Integrus Architecture, P.S.
117 S Main Street
Seattle, WA 98104
(206) 628-3137

The additions, clarifications and corrections contained herein shall be made to the Project Manual, Drawings and Schedules for the above referenced project, and shall be included in the scope of work and proposal to be submitted.

Sartori Elementary School

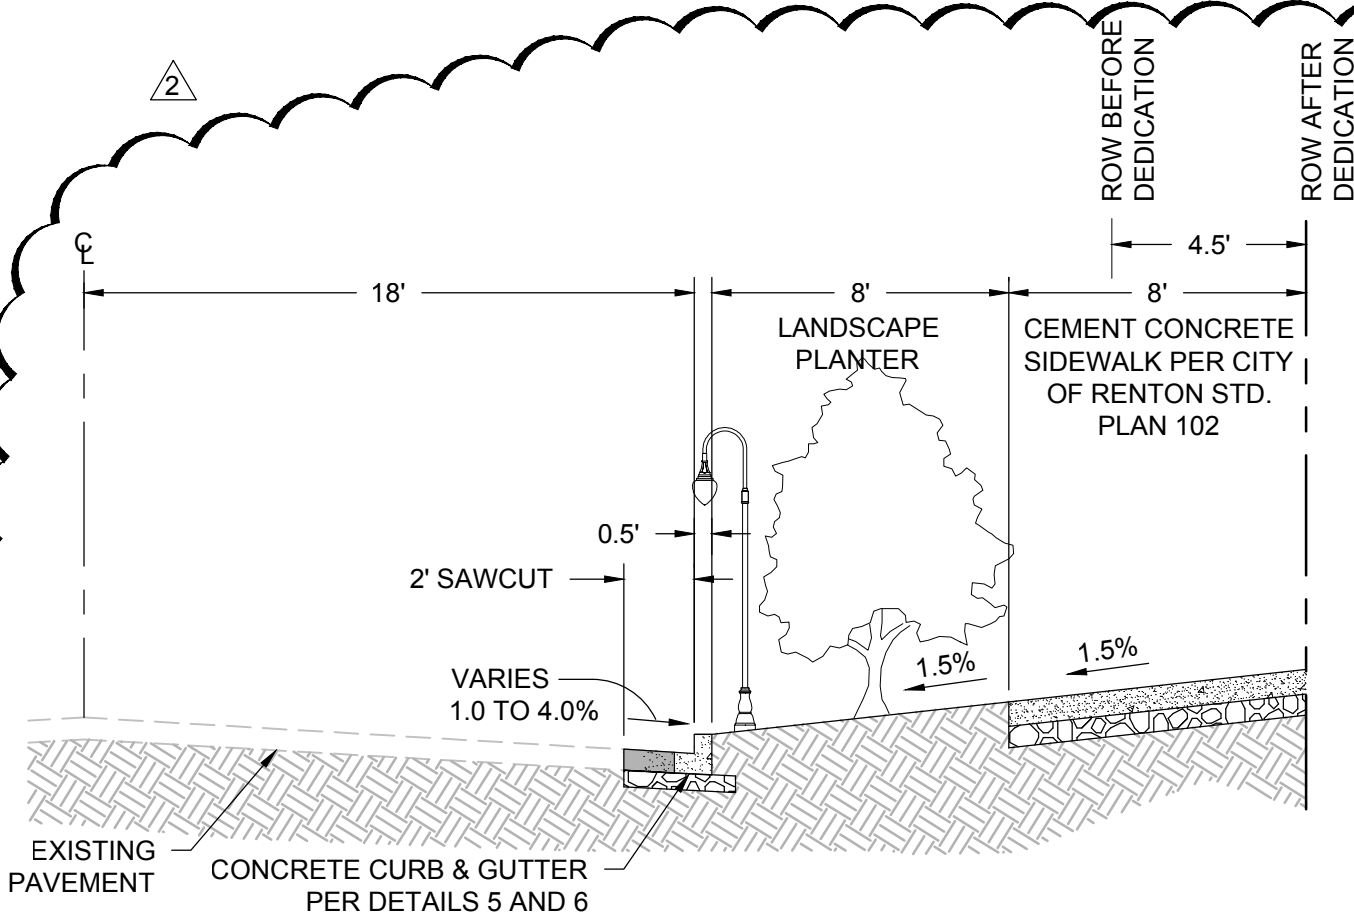
Item #C25 C7.2 – STORM DRAINAGE NOTES AND DETAILS II
ADD #03 **Add** detail No. 3 “Two-Way Cleanout” as indicated by ADC 021.

**NORTH 3RD STREET
(STA 10+82.48 TO STA 13+66.66)**

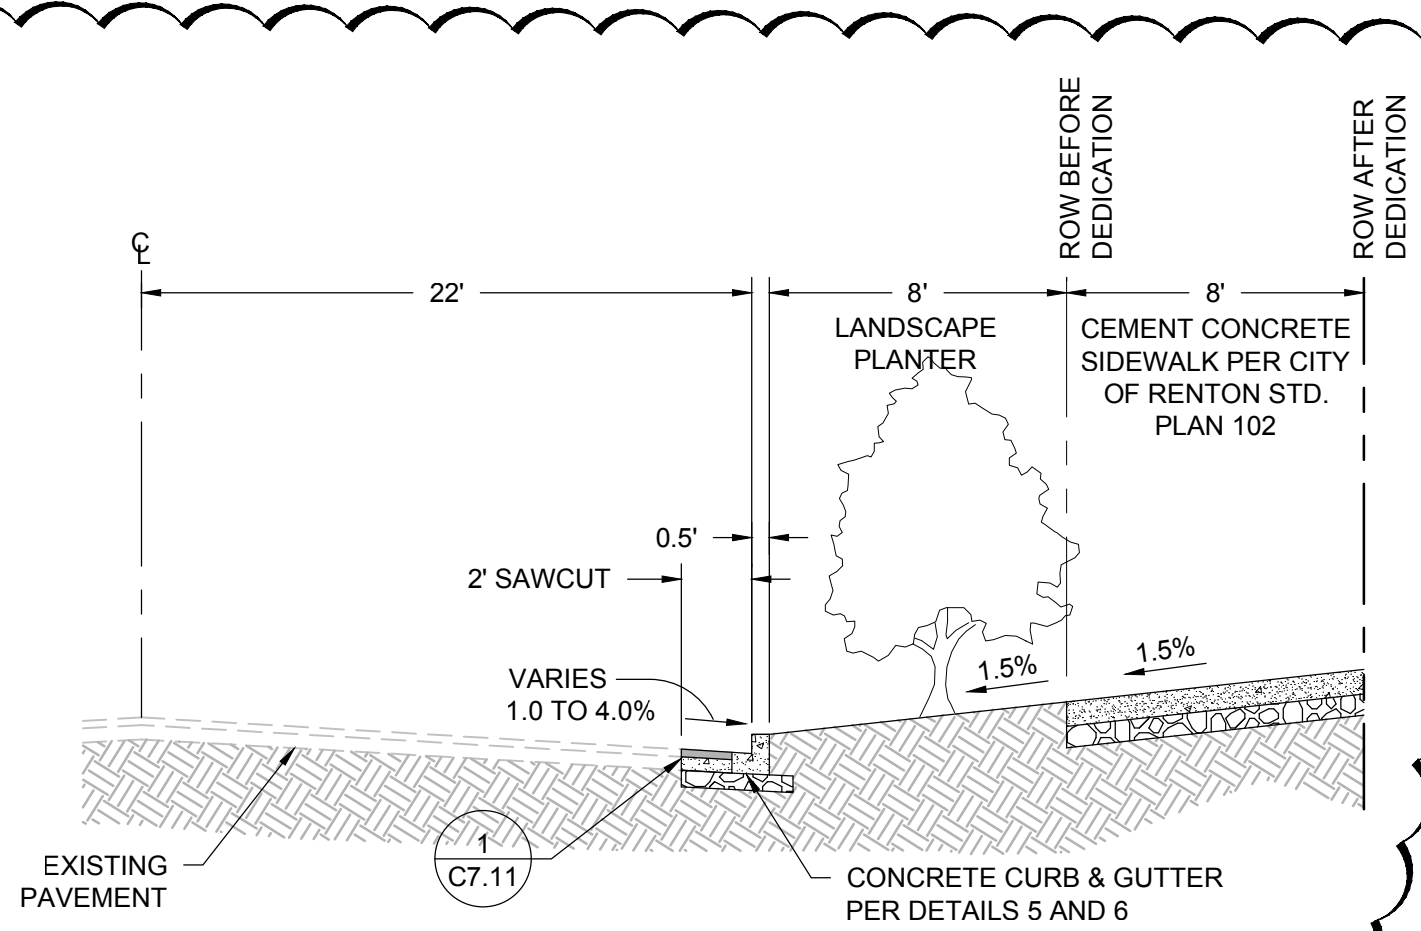
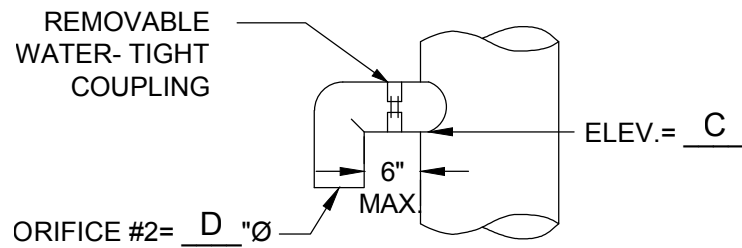
- Item #C27 C7.9 – SURFACE NOTES AND DETAILS II
ADD #03 **Revise** detail No. 2 and No. 3 as indicated by ADC 022 to reflect the new light pole along North 3rd Street and North 4th Street paving section consisting of asphalt pavement over concrete pavement.

CONTROL MANHOLE

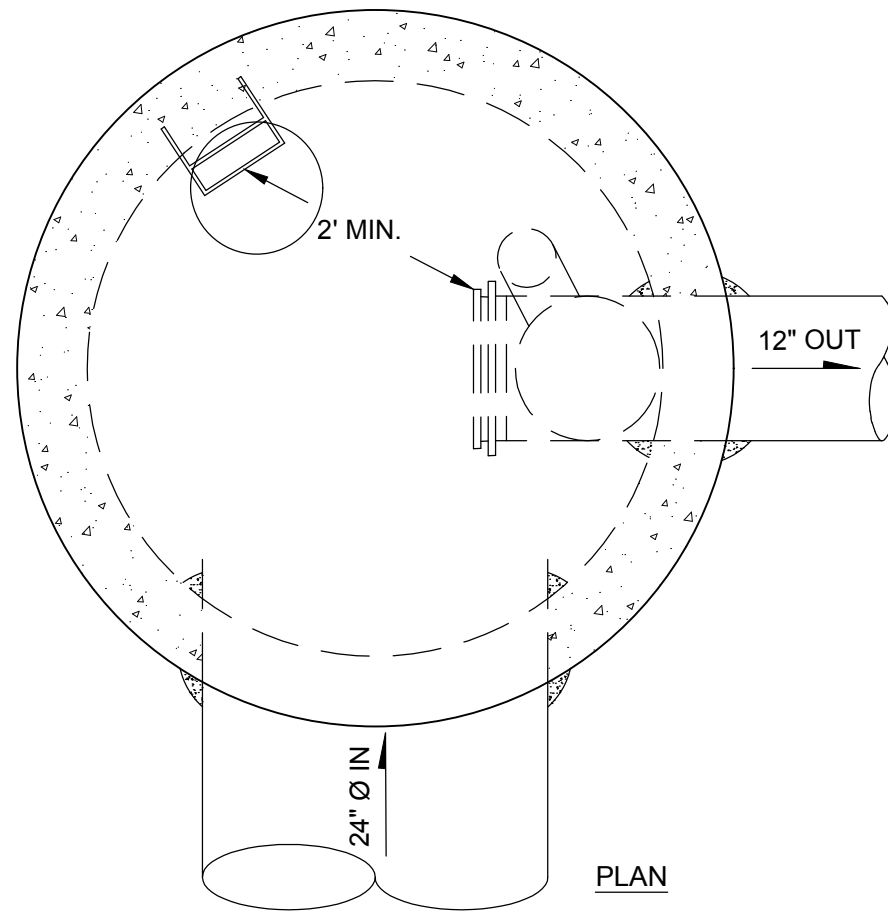
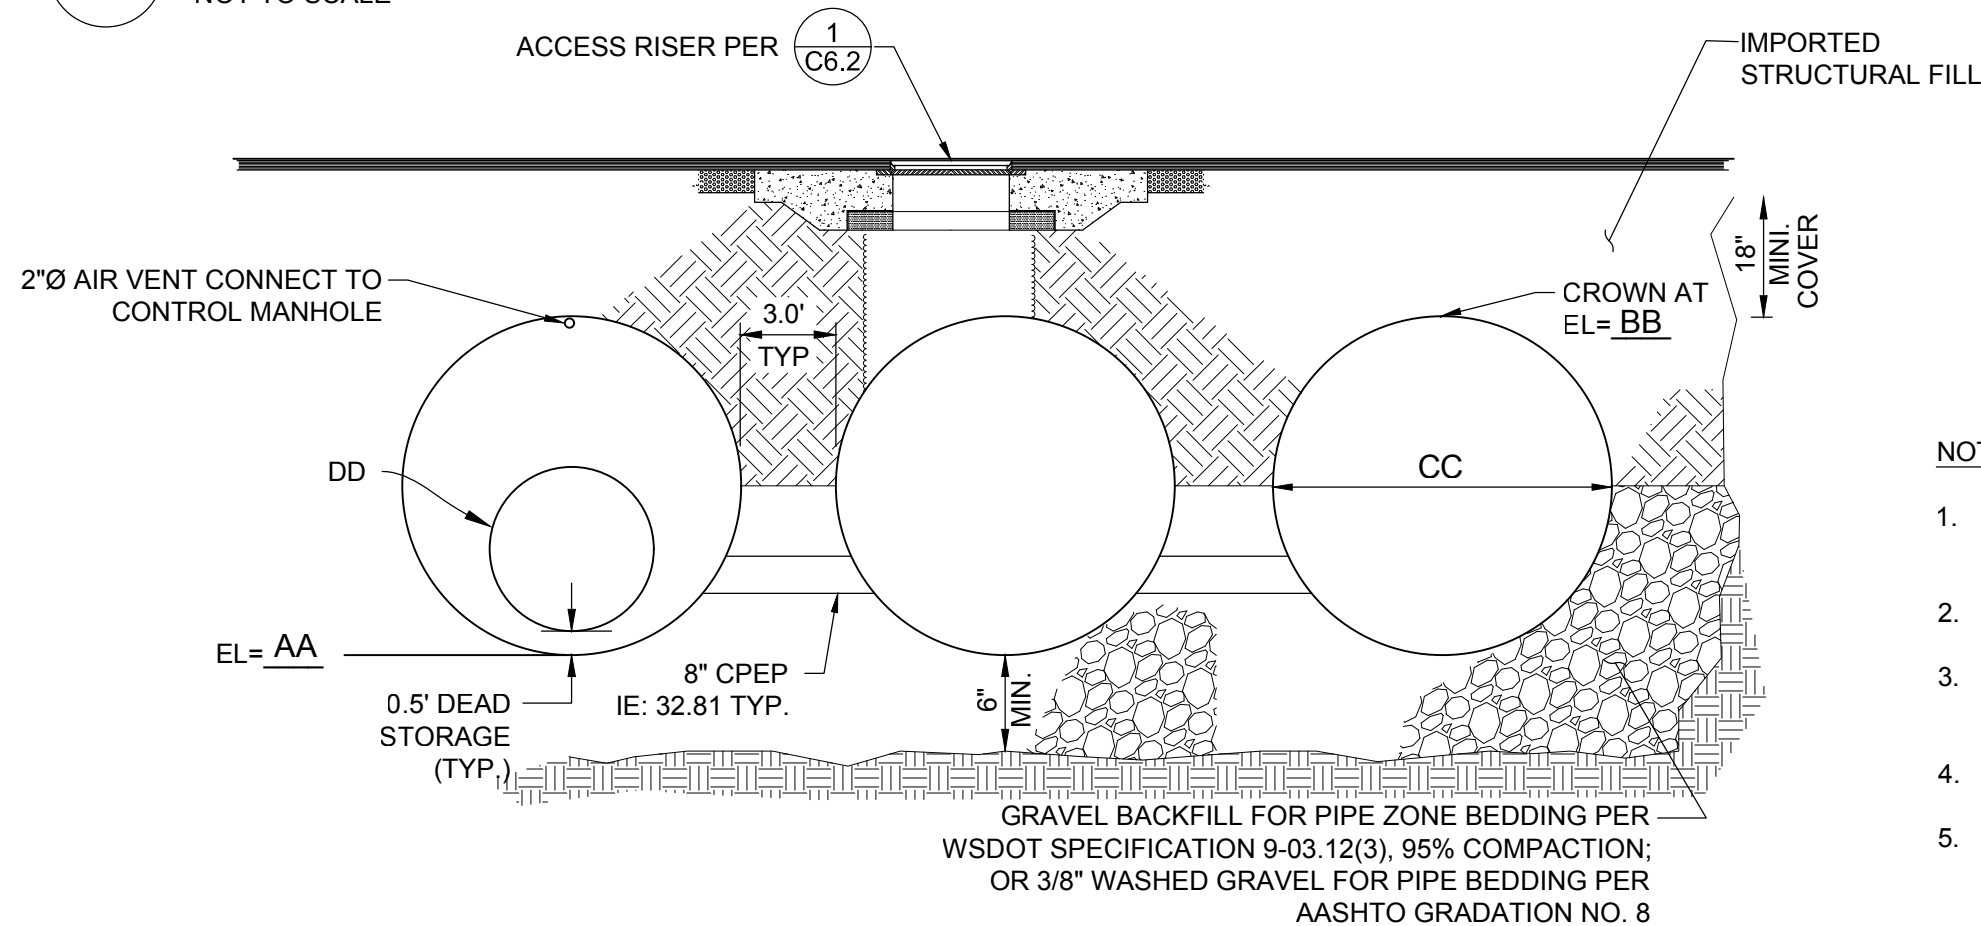
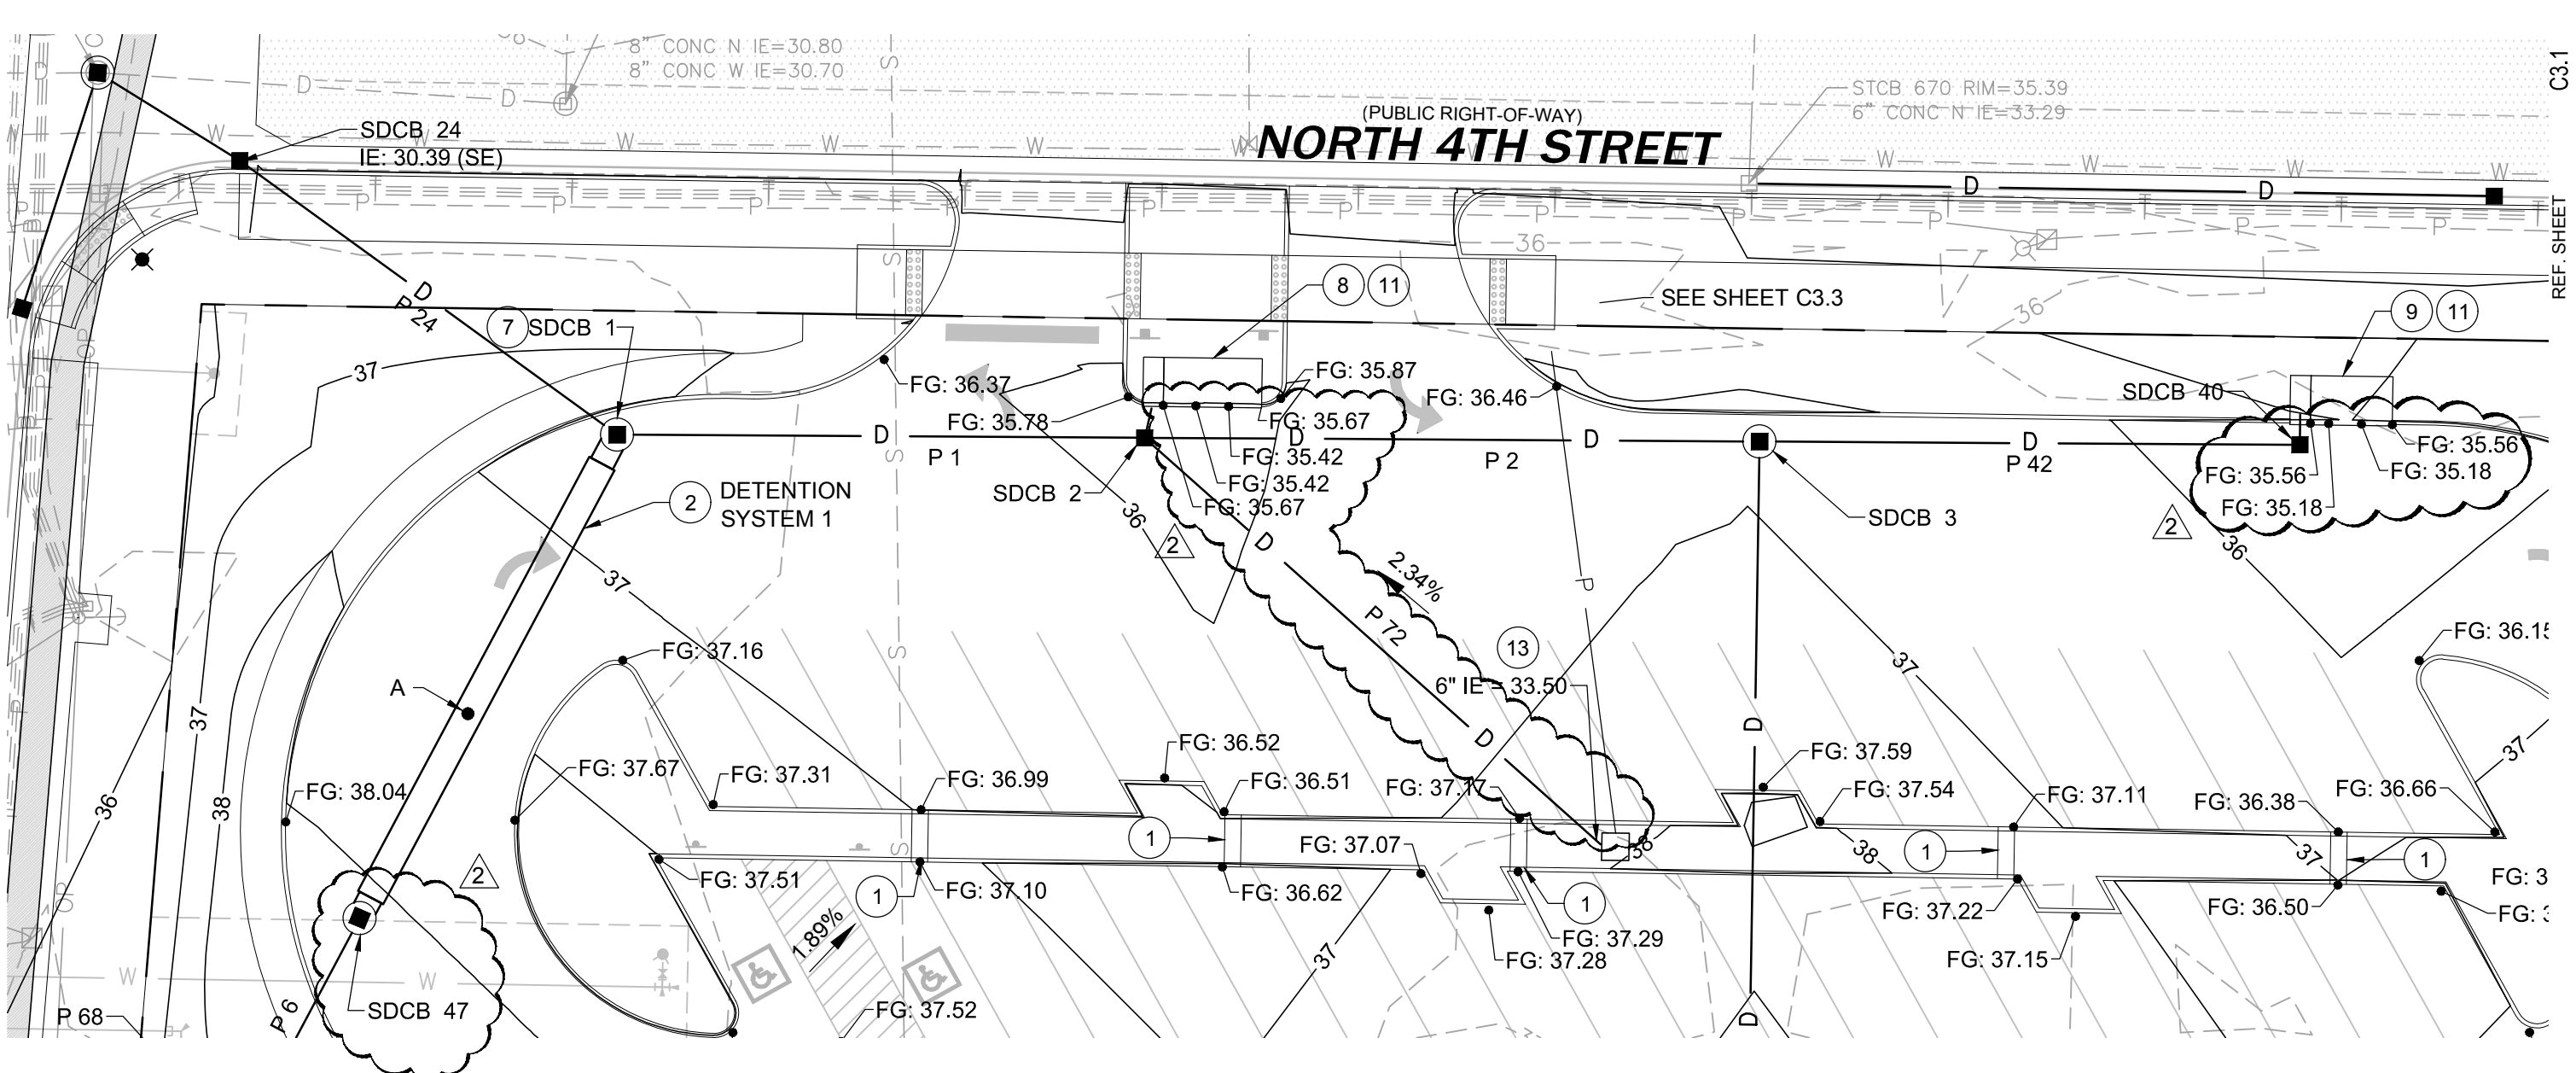
Item #C24 C7.1 – STORM DRAINAGE NOTES AND DETAILS I
ADD #03 **Revise** detail No. 1 and No. 2 detention system No. 3 elevations as indicated by ADC 023.
